**AGENDA**  
**PLANNING BOARD**  
**MEETING TIME 6:30 PM - MAIN MEETING ROOM**  
**JANUARY 7, 2026**

9.I. #2025-400 – Milano Brothers Builders, LLC, Walada Avenue & Arlington Avenue, Block 158, Lot 1; Block 159, Lot 3; Block 122, Lot 122, Located In The R-7 Zone.

## TECHNICAL MEMORANDUM

**DATE:** December 19, 2025  
**BOARD:** Planning Board  
**APPLICATION:** Milano Builders  
Walada Avenue & Arlington Avenue  
Block 122, Lot 122; Block 158, Lot 1; Block 159, Lot 3  
Preliminary & Final Major Subdivision with Variances

**LIGHTING PLAN**

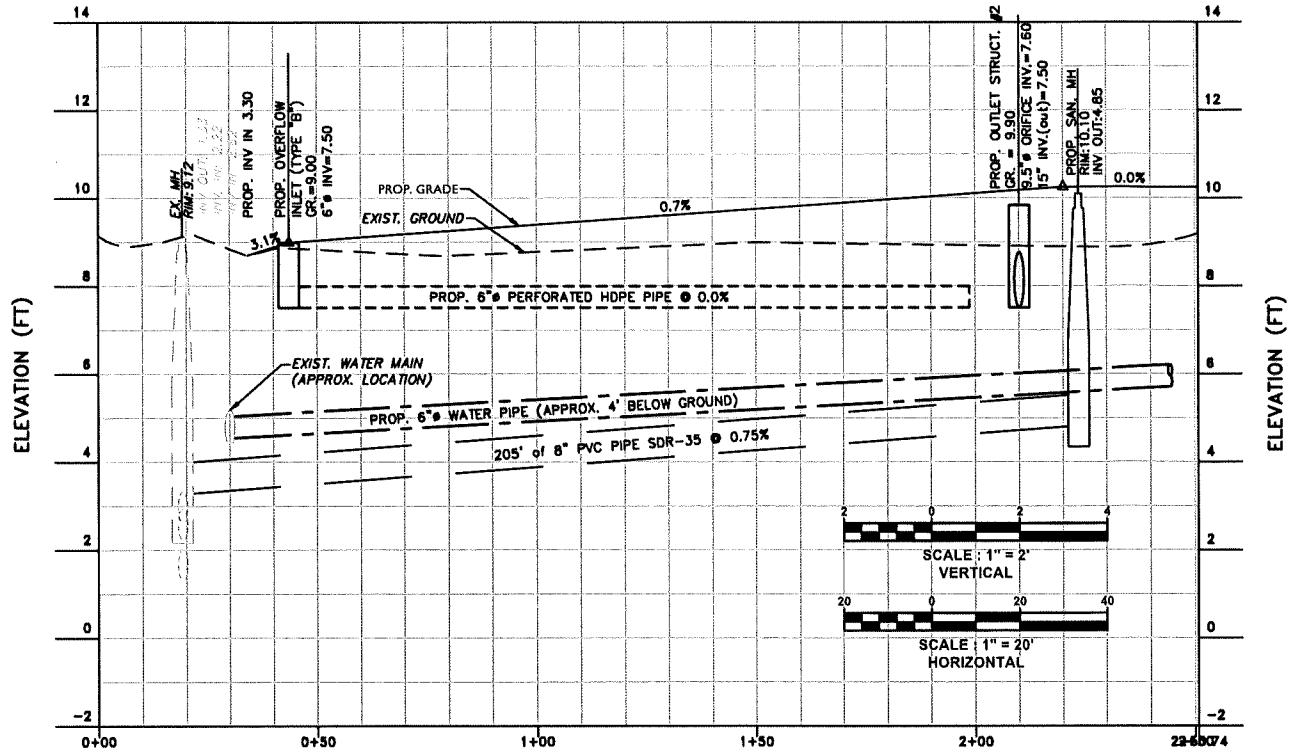
2. Per section 540-528.C.12(a) of the Ordinance, light spillage shall not exceed 0.5 foot-candles beyond any property line. Based on the proposed lighting levels it appears that there is spillage into Lots 4 and 5 exceeding 0.5 fc. The plans shall be revised to address this. The applicant shall also address any issues with glare and provide adequate shielding for nearby residences.

3. The applicant shall review the lighting at the southern curb ramp on Walada Avenue. It appears an existing streetlight on Walada will provide additional illumination for this crossing. However, this was not modeled in the lighting plan. The applicant shall confirm that the crossing will be adequately lit.

4. A Light Pole Foundation construction detail shall be provided.
5. The lighting schedule and plans shows a quantity of 5 total light poles, but the colonial post top standard detail states 6 total streetlights. The applicant shall revise the plans accordingly.

**STONE TRENCH DETAIL**  
NO SCALE

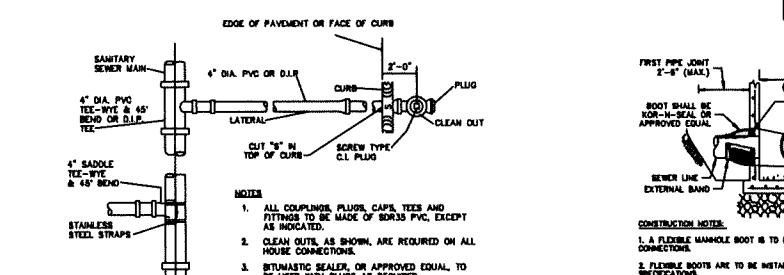
10. Applicant shall provide the offsite (adjacent lots) topo and contours to ensure no offsite runoff sheet flows onto adjacent properties.
11. Applicant shall revise the width of the Stone Trench Detail from 5.5' to 10' in the plan view detail.

**LANDSCAPE PLAN**

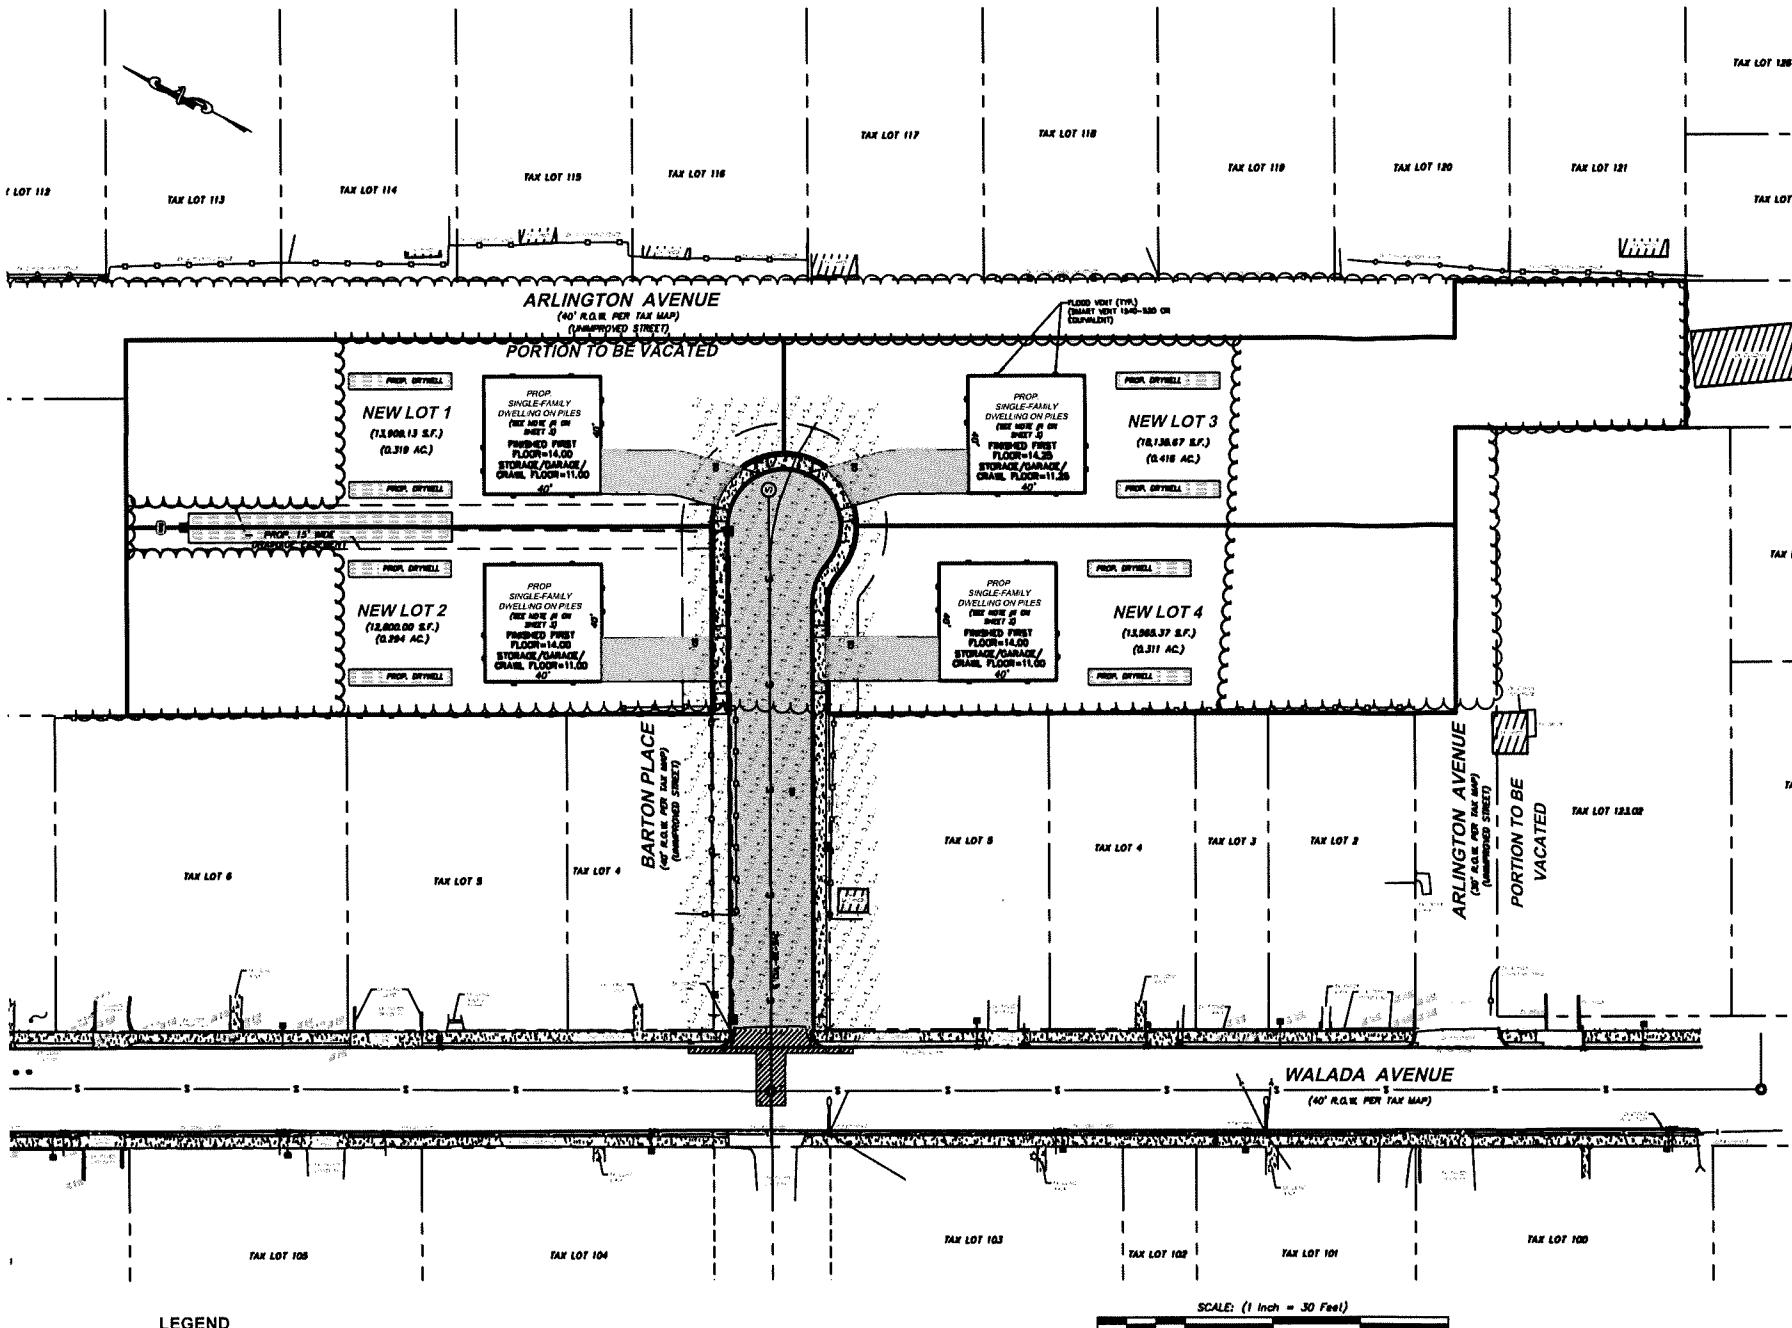
- b. Section 540-645E(2) requires that street trees shall have a minimum caliper of three (3") inches measured one (1') foot from the butt. The Landscape Plan notes the caliper between 2.5" to 3". The plans shall be revised to comply with this ordinance requirement.

9. Ordinance §540-645 requires street trees to be planted at a maximum spacing of 30 ft. on center. Based on a total frontage of 209 FT, 7 street trees are required whereas 5 are proposed. The plans shall be revised to comply, or a design waiver will be required.

10. In addition to street tree requirements, Ordinance §540-622.B.6. requires 10 additional trees per acre to be planted throughout subdivisions, whereas no additional trees are proposed. The plans shall be revised to comply, or a design waiver will be required.

11. Ordinance §540-645.E.2. requires shade trees to have a minimum caliper size of three (3) inches, whereas, the plans note 2.5 to 3 inches. The plan shall be revised to provide a minimum of 3-inch caliper.
